## Product change notification (PCN)

<b>Title / short description</b>	Optimization of the current bar contour on (G)IC 2,5/...-ST(G)(F), DFK-MSTB 2,5/...-STF and (U)MSTBHK 2,5
<b>Affected article category</b>	PCB terminal blocks and PCB connectors
<b>Change category</b>	Form and appearance
<b>Change number</b>	PAA210100-00
<b>Reason for PCN/PDN Revision</b>	PCN creation

# PAA210100 Comparison

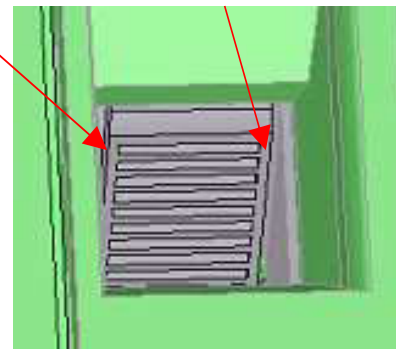
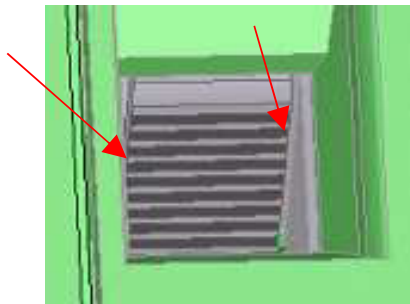
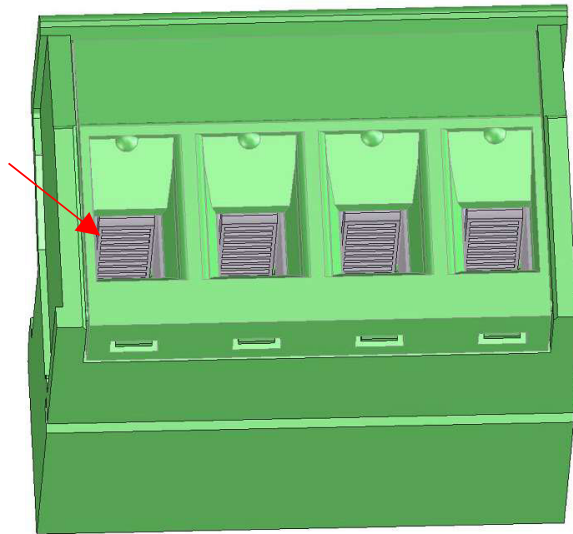
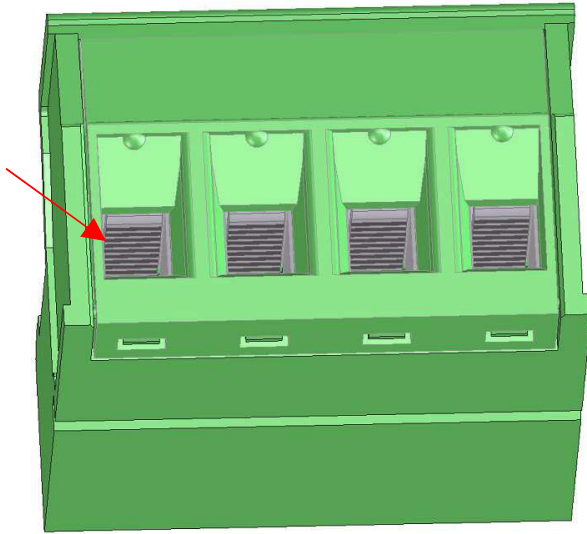
In order to optimize the manufacturing processes, the current bars will have a thin, continuous bridge on the outer edges without fluting in the area of the conductor connection. A visual comparison of old/new is provided in the attachment. The change has no effect on the technical properties of the item. The batch number will not be increased.
